A4LD UPDATE HANDBOOK INDEX

FORD A4LD

"UPDATE HANDBOOK"

Figure 77

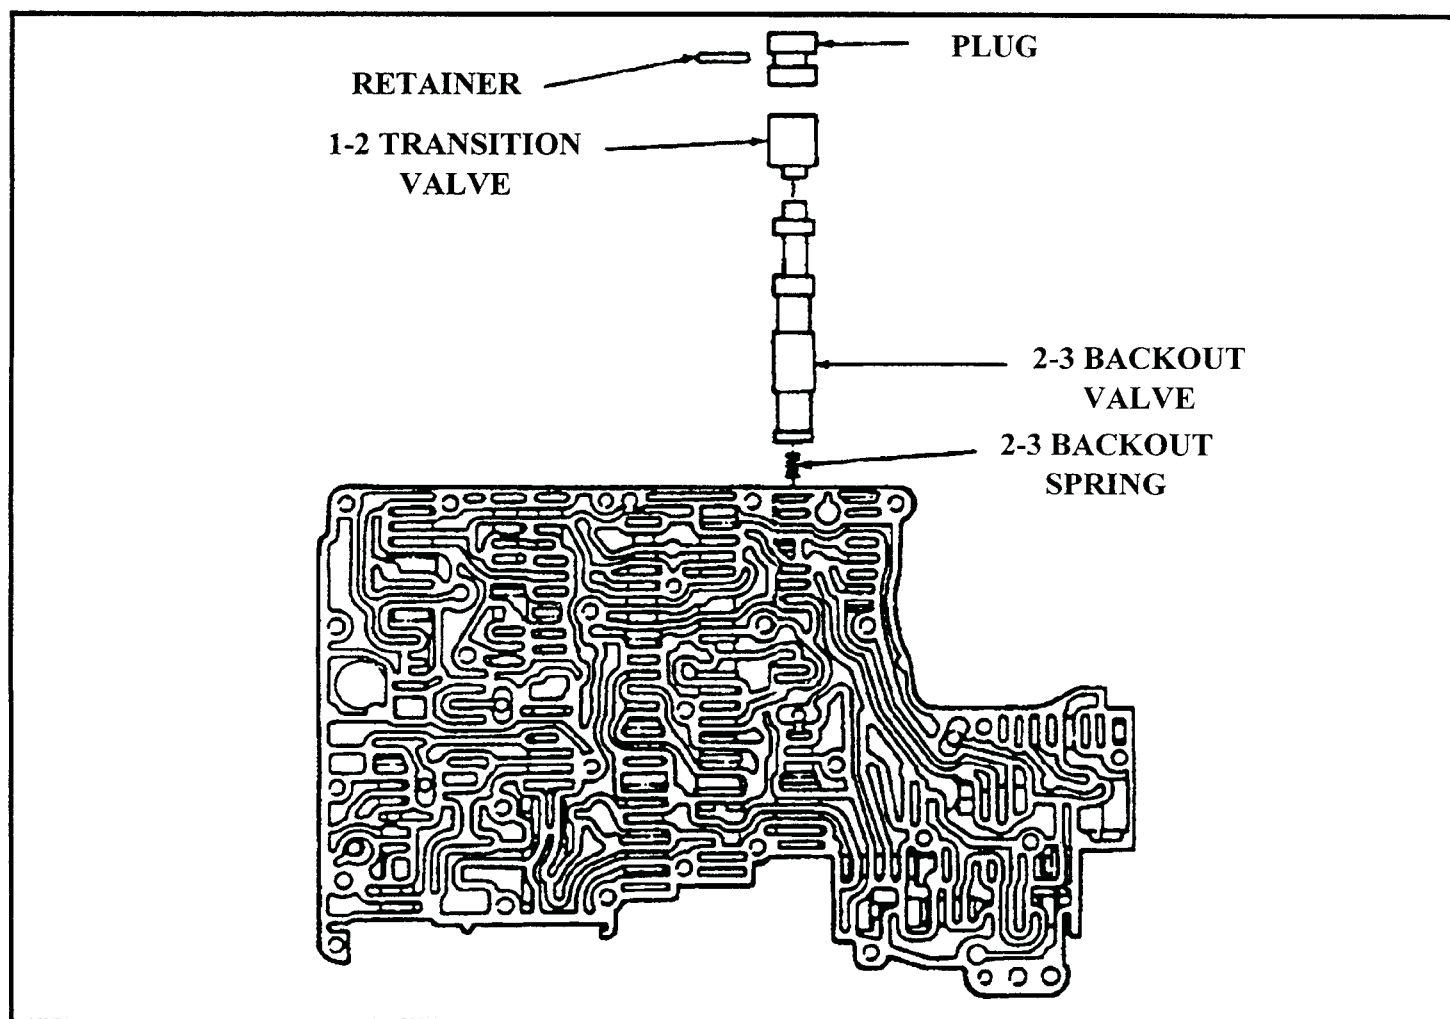
CORRECTION: A new 2-3 backout valve spring is available from Ford that has a revised calibration. It is light blue in color. See Figure 77 for proper bore identification and spring location.

2-3 Backout Valve Spring..... F3TZ-7D230-B

Figure 81

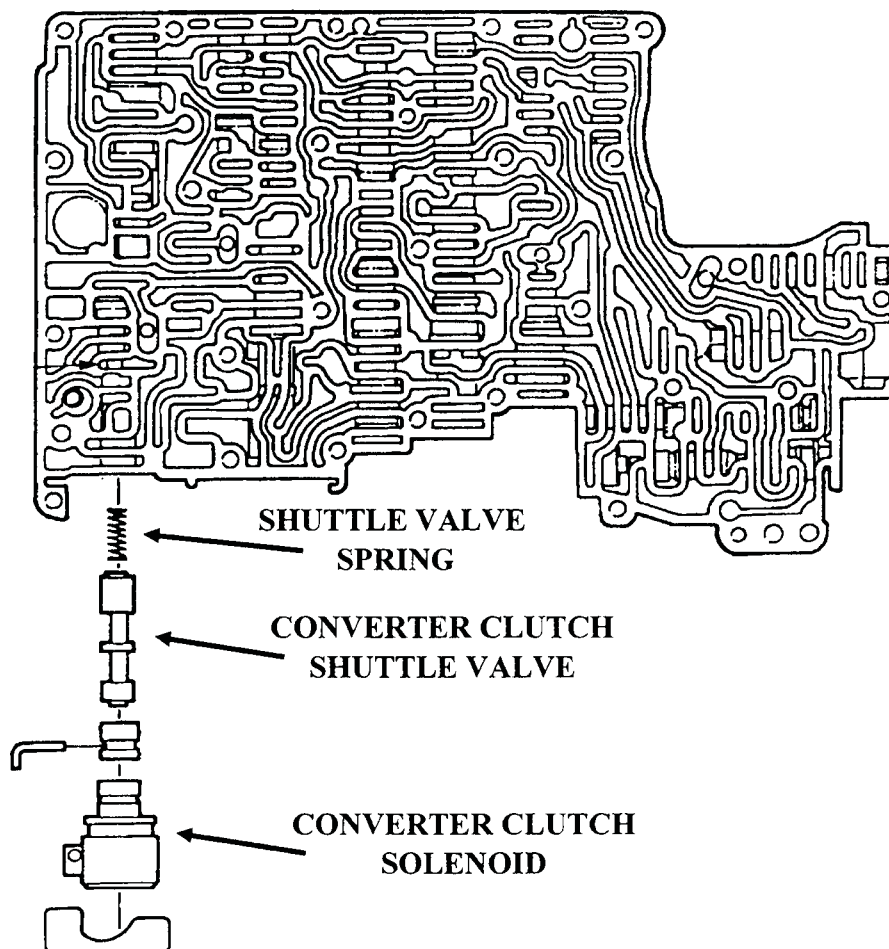
CORRECTION: Replace the broken converter clutch shuttle valve spring with updated spring (See Figure 81).

Shuttle Valve Spring.....E5TZ-7L490-A

Figure 82

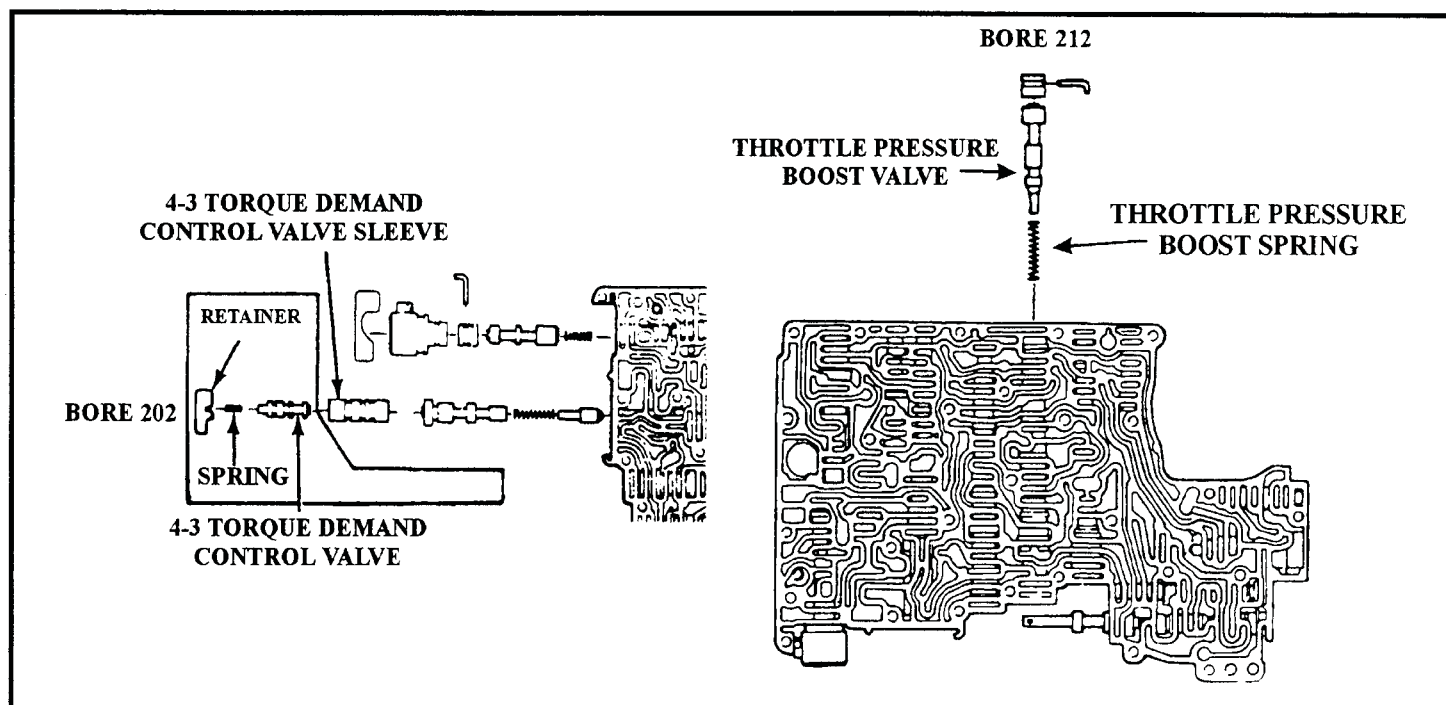
CAUSE: The cause may be an incorrectly calibrated throttle pressure boost spring and 4-3 torque demand control valve spring (See Figure 82).

CORRECTION: Replace both the throttle pressure boost spring and 4-3 torque demand control valve spring

Service Kit..... E5TZ-7E479-A

Figure 83

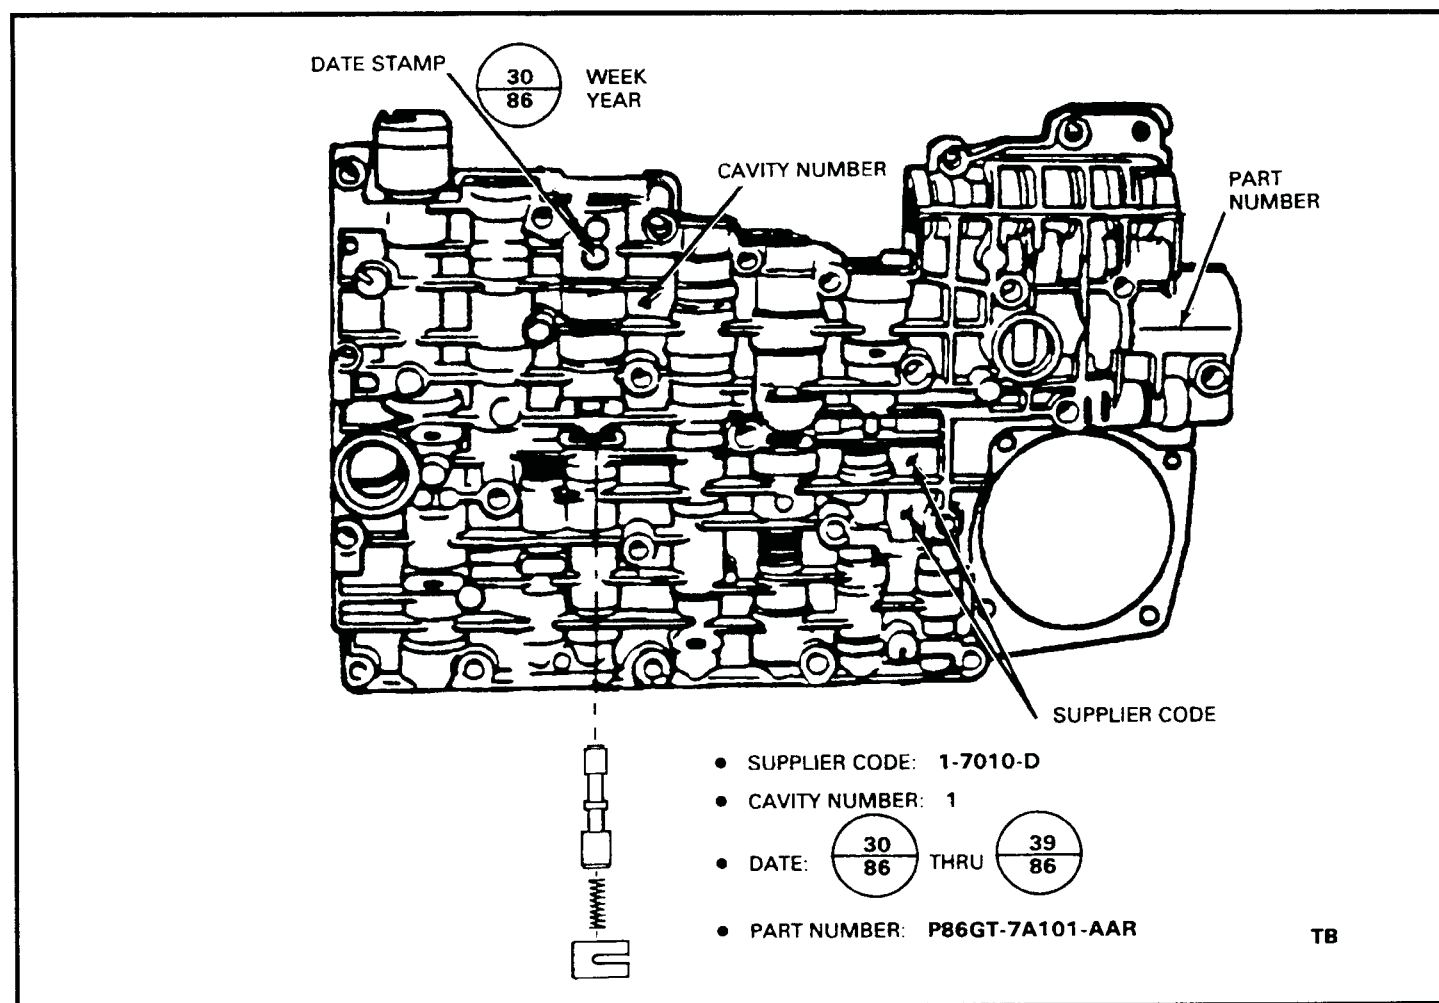
CORRECTION: To compensate for the casting flaw, replace the 3-2 kickdown timing valve with an updated valve (See Figure 83).

3-2 Kickdown Timing Valve.....E7TZ-7D045-A
